Economic Commission for Europe**Inland Transport Committee****World Forum for Harmonization of Vehicle Regulations****Working Party on General Safety Provisions****116th session**

Geneva, 1–5 April 2019

UN Regulation No. 26 (External projection for passenger cars)**Proposal for Supplement 4 to the 03 series of amendments to
UN Regulation No. 26 (External projection for passenger
cars)****Submitted by the expert from France***

Figure 0
Example of parts distribution

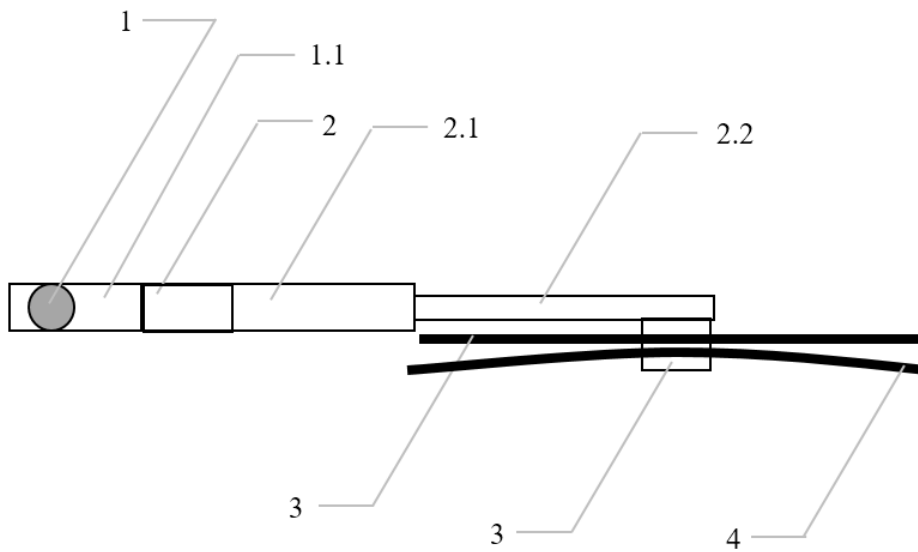
- "6.4. Windscreen wipers
- 6.4.1. The windscreen wiper fittings shall be such that the wiper shaft (**number 1 in Figure 0**) is furnished with a protective casing (**number 1.1 in Figure 0**) which has a radius of curvature meeting the requirements of paragraph 5.4. above and an end surface area of not less than 150 mm². **The holder (head, main and/or other parts, i.e. numbers 2, 2.1 and 2.2 in Figure 0) are designed with a radius of curvature meeting the requirements of paragraph 5.4. above.** In the case of rounded covers, these shall have a minimum projected area of 150 mm² when measured not more than 6.5 mm from the point projecting furthest. These requirements shall also be met by rear window wipers and headlamp wipers.

- 6.4.2. Paragraph 5.4. shall not apply to the wiper blades (**number 4 in Figure 0**), ~~or~~ ~~to any~~ **to supporting members (number 3 in Figure 0) or to the functional hinge between the holder head and the holder.** However, these units shall be so made as to have no sharp angles or pointed or cutting parts.

In order to avoid any misunderstanding of which requirements apply to which part of the windscreen wiper, a simple generic drawing presenting the concerned areas seems to be the best way for a coherent application. Geometrical requirements are only applicable on contactable parts (sphere protocol).
